## **SOUTHERN OAKS ESTATES SUBDIVISION,** **UNIT SIX**

APPLICATION NUMBER 6 DATE November 2, 2006

APPLICANT Southern Oaks Estates Subdivision, Unit 6

REQUEST Subdivision

# DETAIL SITE PLAN

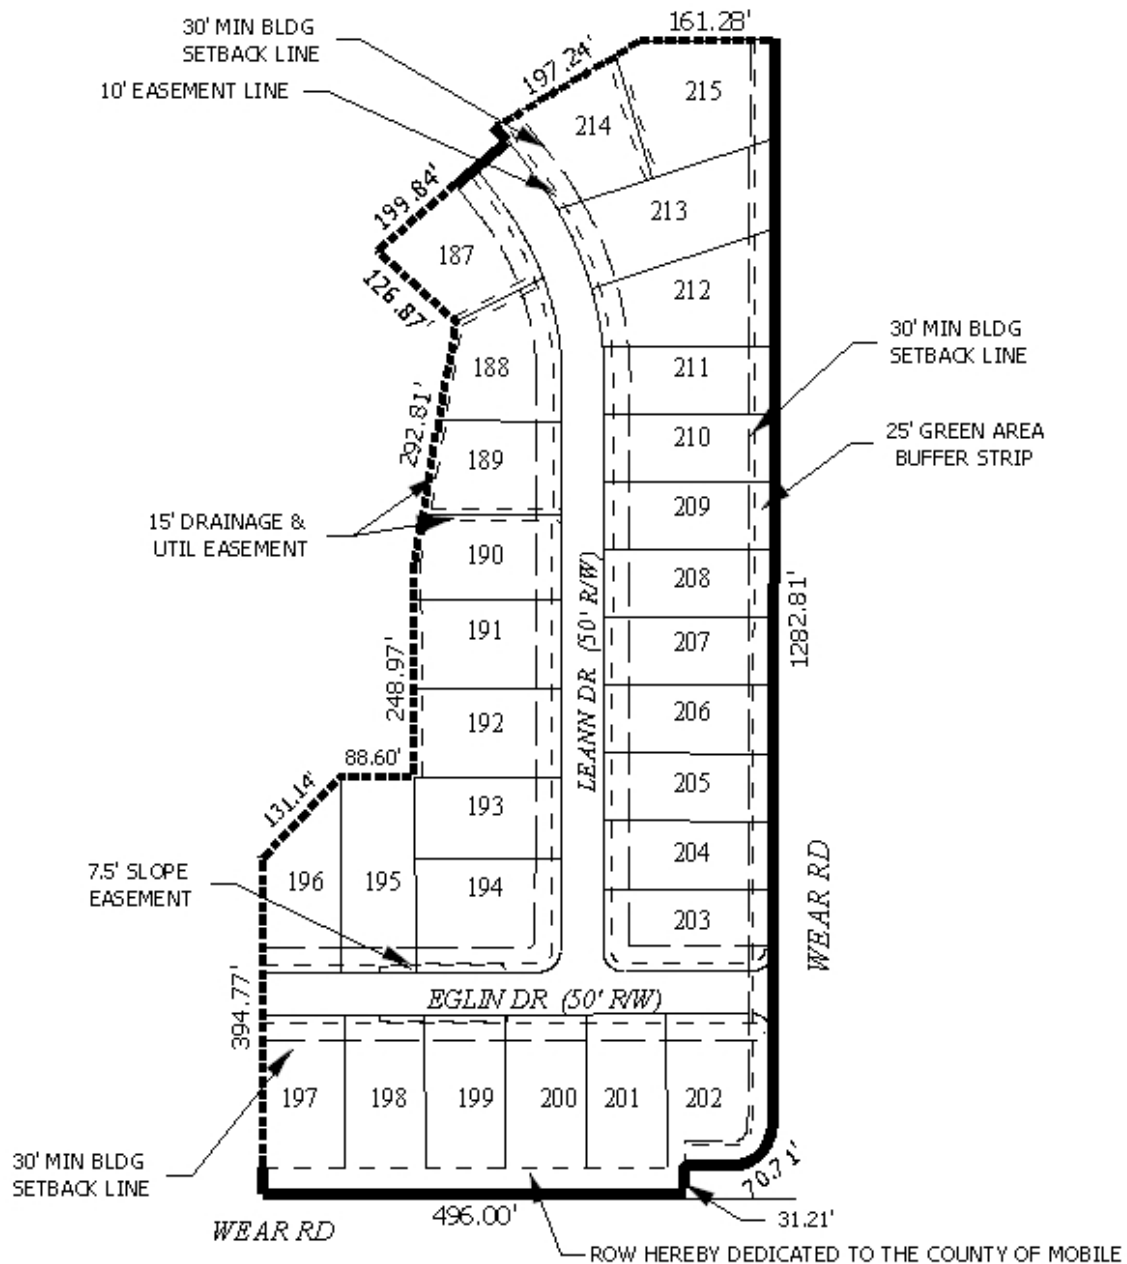
Dedication sufficient to provide 30 feet from the centerline is shown for the unpaved portion of Wear Road, as required for roads without curb and gutter; the same should be required for the paved portion of Wear Road, which has a 50-foot right-of-way but does not appear to have curb and gutter. The application proposes new streets, which must be constructed and dedicated to County Engineering standards prior to signing the final plat. Proposed Lot 215 would only have access to Wear Road, instead of the subdivision streets, and has the potential to be developed differently from the rest of the subdivision. As with the remainder of the development, there is no zoning in Mobile County; thus a note should be placed on the final plat stating that any lots which are developed commercially and adjoin residentially developed property must provide a buffer, in compliance with Section V.A.7. of the Subdivision Regulations.

The purpose of this application is to create a 29-lot subdivision from a portion of a metes and bounds parcel. The boundaries of the remainder of this parcel (to the North of the site) appear to coincide with floodplain boundaries, and it appears that this site is meant to be reserved and not developed; there are no street stubs to it from the existing or proposed surrounding development, and the words “common area” are shown outside the site boundaries shown on the plat, on the North side. However, the record plat for Unit 5 shows that the “common area” North of the site does not constitute the balance of the parcel. As the Subdivision Regulations do not allow the partial subdivision of a property, the final plat should illustrate *all* of the remainder of this parcel and label it “common area”. The plat already illustrates the note giving responsibility for maintenance of common areas to property owners. Although the plat indicates that wetlands are beyond the boundaries of the proposed development, the site may still be considered environmentally sensitive, and federal, State, and local approvals may still be required prior to development. Finally, as the legal description provided has several errors, this should be revised for errors as well as to include the “common area” remainder of the parcel.

stormwater and flood control ordinances, prior to the signing and recording of the final plat, if approved. The plat should also be revised to depict contour data, as required by the Subdivision Regulations, and lot sizes should be illustrated in square feet either through labeling or the provision of a table on the final plat.

The plat meets the minimum standards of the Subdivision Regulations and is recommended for Tentative Approval, subject to the following conditions: 1) provision of a certification letter from a licensed engineer to the Planning Section of Urban Development, certifying that the stormwater detention, drainage facilities, and release rate comply with the City of Mobile stormwater and flood control ordinances, prior to the signing and recording of the final plat; 2) depiction on the final plat of the full remainder of the parcel, and that it be labeled as “common area”; 3) revision of the legal description to correct errors and include the common area remainder of the parcel; 4) dedication of sufficient right-of-way to provide 30 feet from the centerlines of both the unpaved and paved portions of Wear Road; 5) construction and dedication of the new streets; 6) depiction of contour data, as required by the Subdivision Regulations; 7) placement of a note on the plat stating that any lots which are developed commercially and adjoin residentially developed property must provide a buffer, in compliance with Section V.A.7. of the Subdivision Regulations; and 8) labeling of all lots with size in square feet, or placement of a table on the plat containing the lot size information.
